**CITY OF WINTER PARK
PLANNING AND ZONING BOARD**

**Staff Report
March 6, 2018**

SPR 18-03 REQUEST OF WINTER PARK DESIGN FOR APPROVAL TO CONSTRUCT A NEW 5,758 SQUARE FOOT SINGLE-FAMILY HOME LOCATED AT 1234 LAKEVIEW DRIVE ON LAKE VIRGINIA, ZONED R-1AAA.

REQUEST OF VERAX INVESTMENTS, LLC FOR: CONDITIONAL USE APPROVAL TO CONSTRUCT A TWO STORY, 20,000 SQUARE FOOT MEDICAL AND GENERAL OFFICE BUILDING ON THE PROPERTY AT 1111 WEST FAIRBANKS AVENUE, ZONED C-3.

Option 1

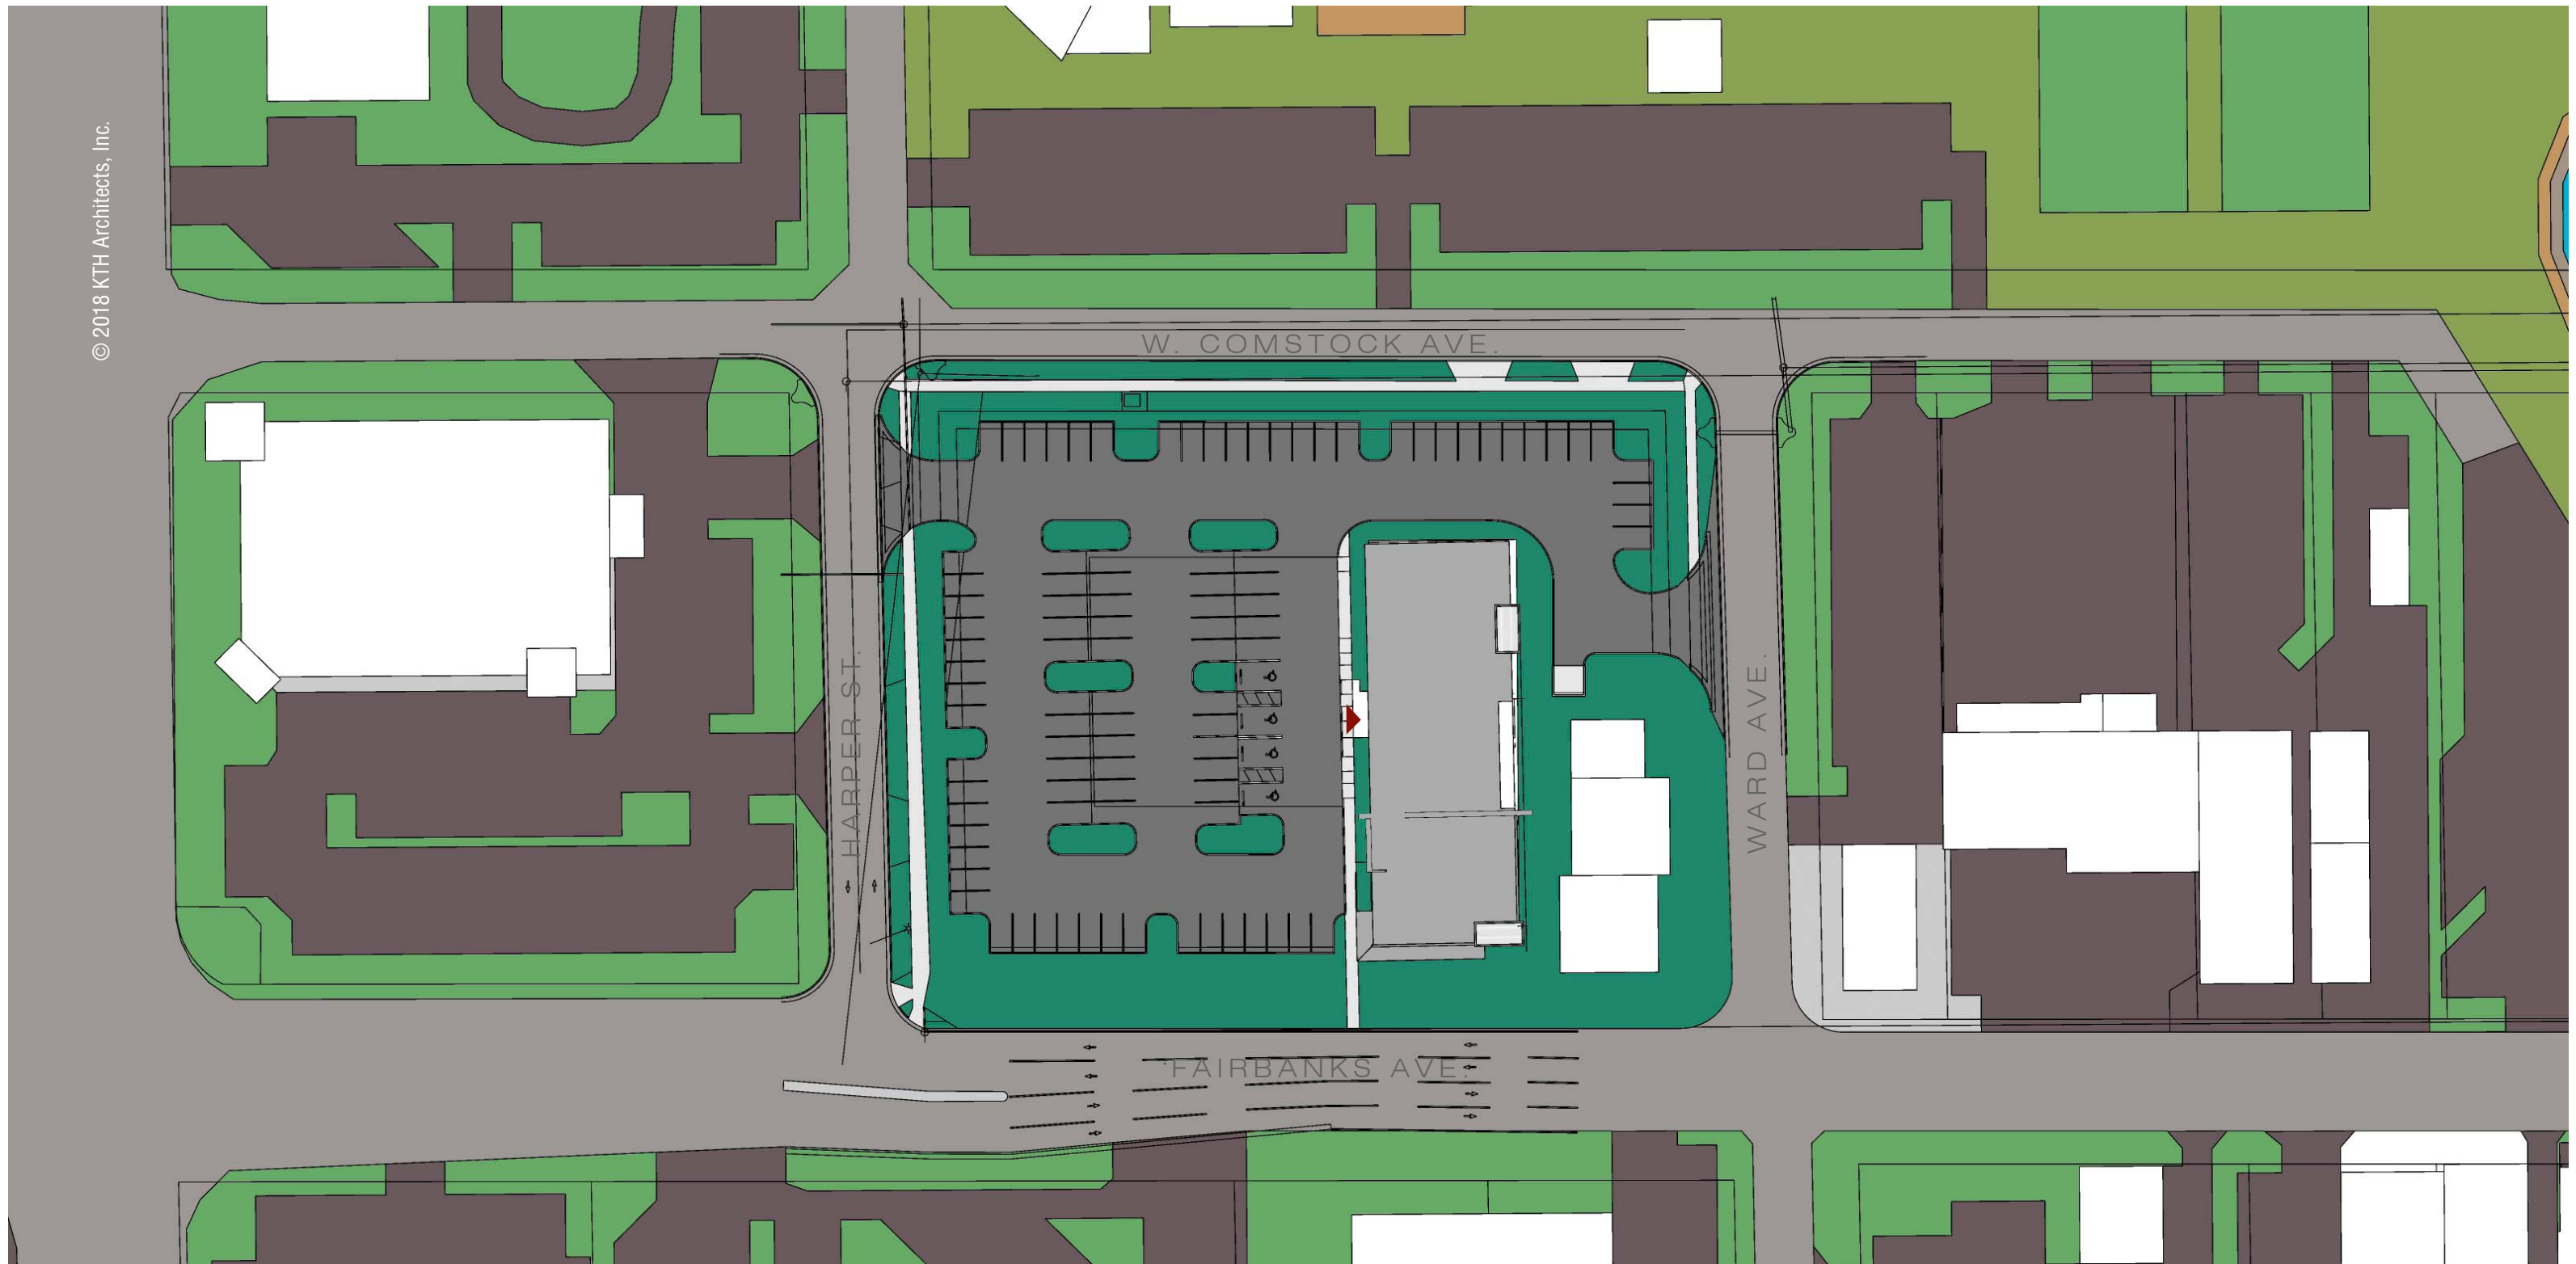
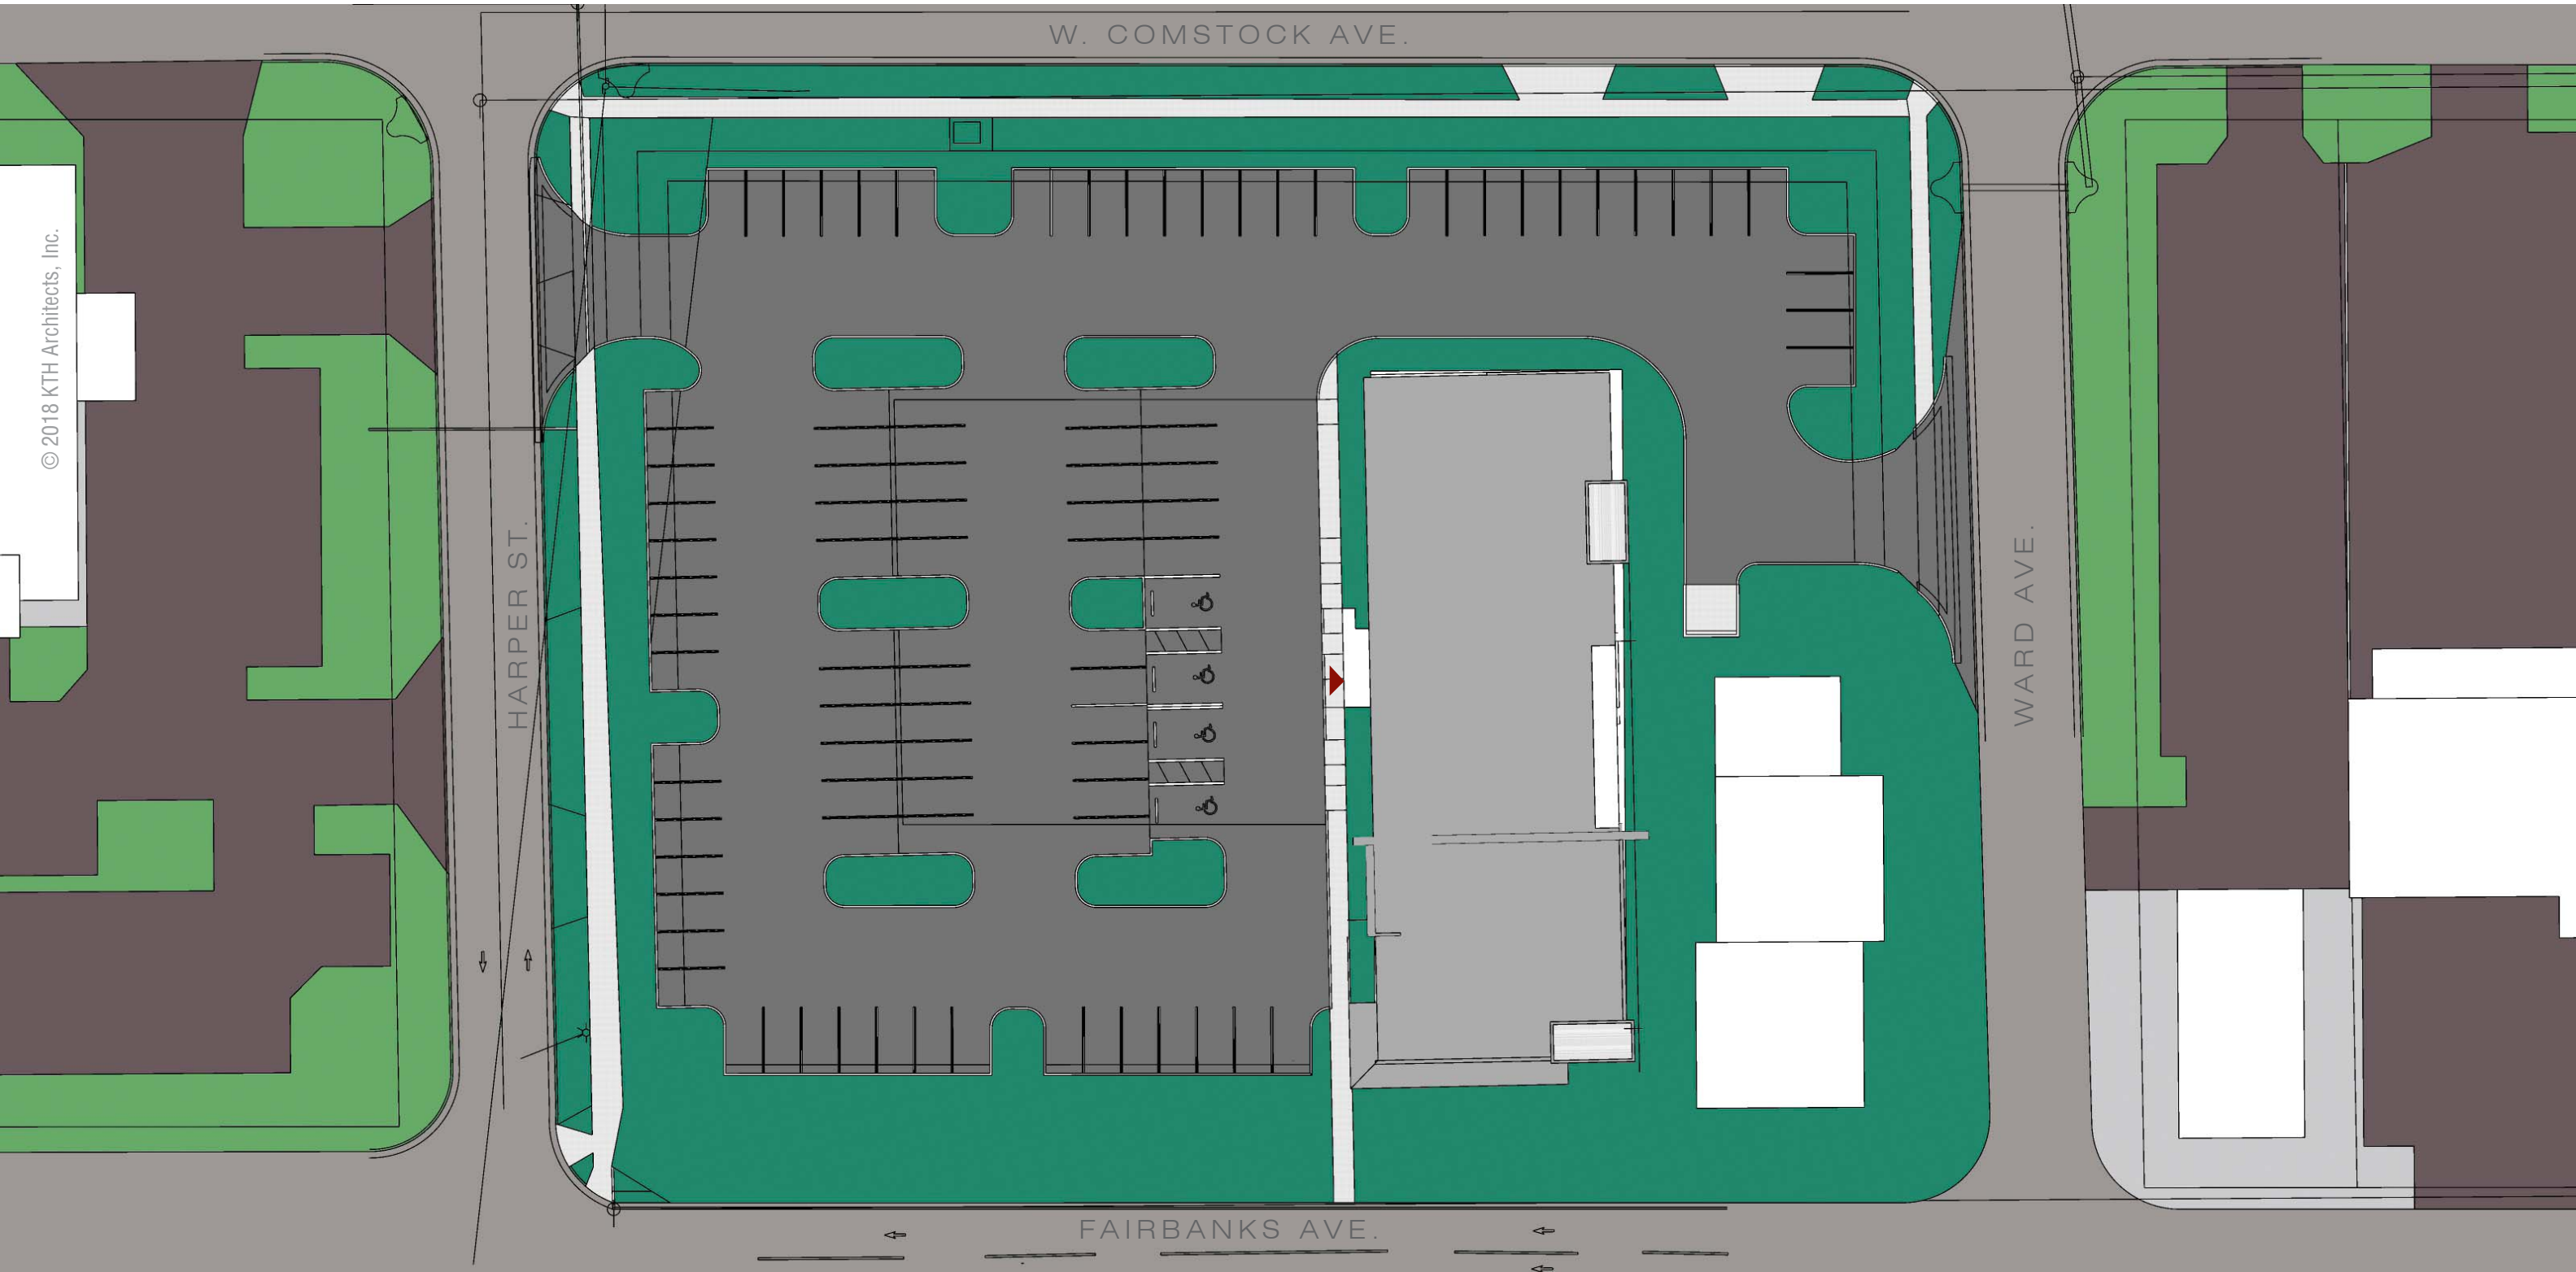
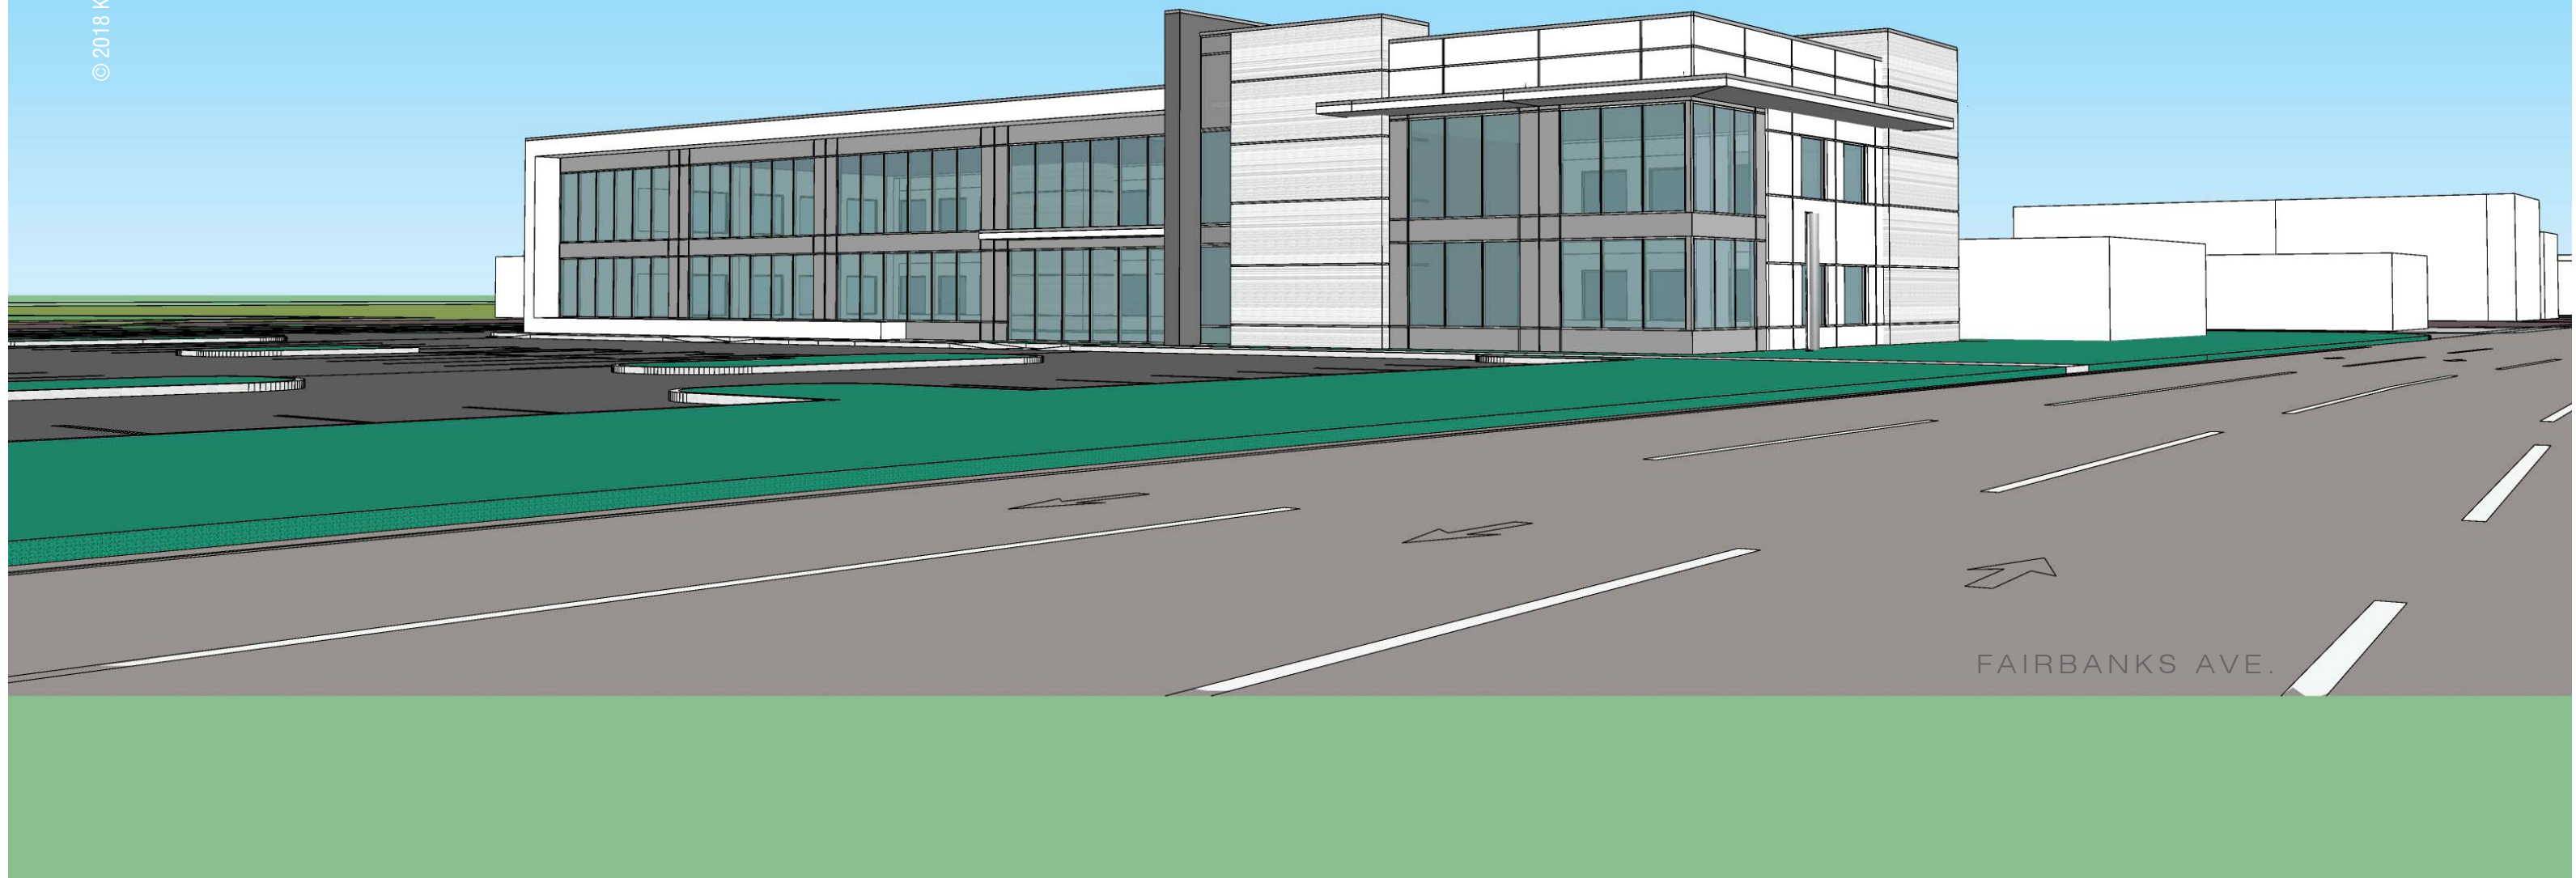
Architectural Image: Perspective elevations are included in the agenda materials depicting the look of the proposed office building. It is a contemporary architectural style. Again, as with some previous applications (Rollins Facility Bldg. & Sprouts) the staff will condition this request on a return to P&Z/City Commission with revised architectural images for some potential improvements in design or material selection.

- 1. That the final architectural elevations and materials of the proposed office building, be revised to a traditional architectural style other than a contemporary or postmodern style and that such architectural elevations and materials be subsequently approved by the P&Z Board and City Commission after input and dialogue with the city architect.**
